RE: Technical Field Visit, Deer Creek Waste Rock Storage Facility, PacifiCorp, Deer Creek Mine, C/015/0018

TECHNICAL FIELD VISIT

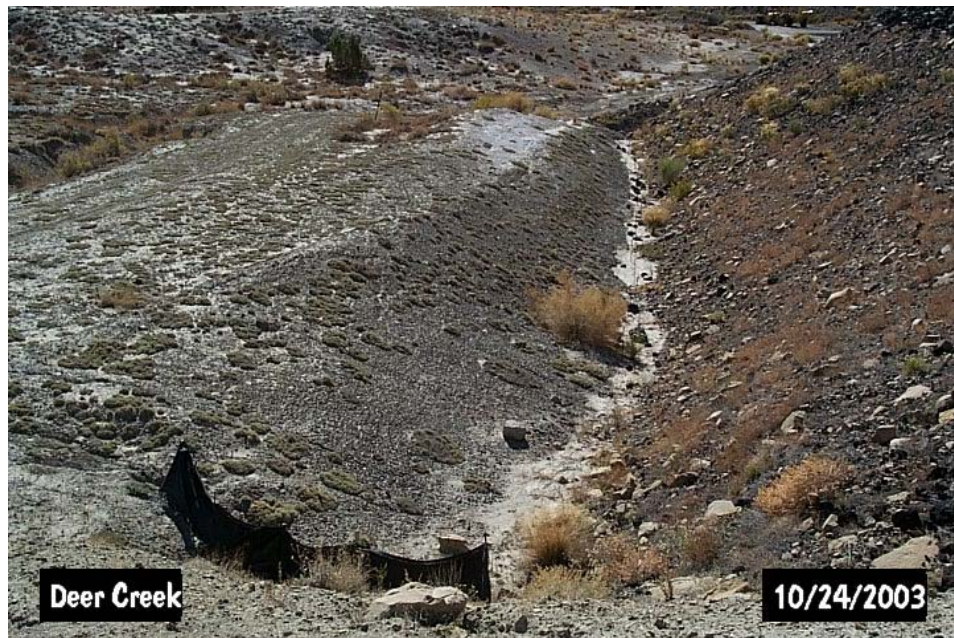
1. The undisturbed drainage bypass ditch, on the north and west sides of the Phase I waste rock pile (see MRP Plate 4-5), is completely filled with sediment from years of runoff from the undisturbed drainages north of the site (photo P0002131).
  - a. The ditch was built when the site was constructed, around 1989.

- e. The ditch will be cleaned to comply with the MRP.
2. There is a berm made of topsoil on the north, west, and south sides of the waste pile.
- a. The outslope of the topsoil berm is an ASCA (see Plate 4-5 and photo P0002129).

- i. The plan isn't clear, but apparently silt fence located between the berm and ditch is the sediment control measure for this ASCA.
    - ii. Without a functioning undisturbed drainage bypass ditch, the silt fence has been keeping sediment from the undisturbed areas out of the waste rock site rather than retaining sediment on the site.

- 1. At several locations, the silt fence has been knocked-down or torn by water and sediment coming from the undisturbed side: this resulted in NOV #NO3-49-4-1.

- c. On the north side, the berm, silt fence, and presumably the ditch extend east beyond the waste rock pile.
    - i. This section of the berm is considerably lower than that adjacent to the waste rock (photo P0002135.)

- ii. In this section extending to the east, the berm has been topped by undisturbed runoff, the top of the berm has been eroded and sections of silt fence flattened (photo P0002133.)

3. Most of the waste rock pile drains to a sedimentation pond, but the east side of the waste rock pile is designated as a BTCA area (see Plate 4-5 and photo P0002133.)

- a. Silt fencing is the sediment control measure for this BTCA area (page 4-13.1 of the MRP).
  - b. The toe of the BTCA area butts against a parallel ridge, which has produced a southward draining channel or ditch between the BTCA area and ridge.

- i. This ditch directs drainage from the BTCA area to the existing drainage channel on the south side of the site.
    - ii. Silt fencing in this ditch has been removed, although the roof-bolt supports are still in place.

- iii. This ditch is also where part of the undisturbed flow over the east end of the topsoil berm (see 3.b.) reports, and silt fence across the head of the ditch treats this flow.

- c. The east end of the pile and the area east of the pile are not readily ground-truthed with what is shown on Plate 4-5.
    - i. Topography appears to have been pretty much ignored when this pre-construction plan was drawn.

- 2. The silt fence will be repaired to abate the NOV.
  - b. Even with the undisturbed bypass ditch full of sediment and the silt fence in disrepair; the topsoil berm isolates the coal mine waste from the undisturbed water and sediment.

- iv. Cleaning the undisturbed bypass ditch should eliminate the problem of undisturbed drainage flowing across this berm and the adjacent disturbed area.

The Permittee is repairing the silt fence and cleaning the undisturbed drainage bypass ditch on the north and west side of the waste pile and restoring the sediment control measures for the BTCA area on the east end of the waste pile.

I'd recommend the Permittee make an as-built drawing of the site. At a minimum, the corners of the pile and a few other prominent features should be GPS'd to see how everything sits in relation to the pre-construction plan.
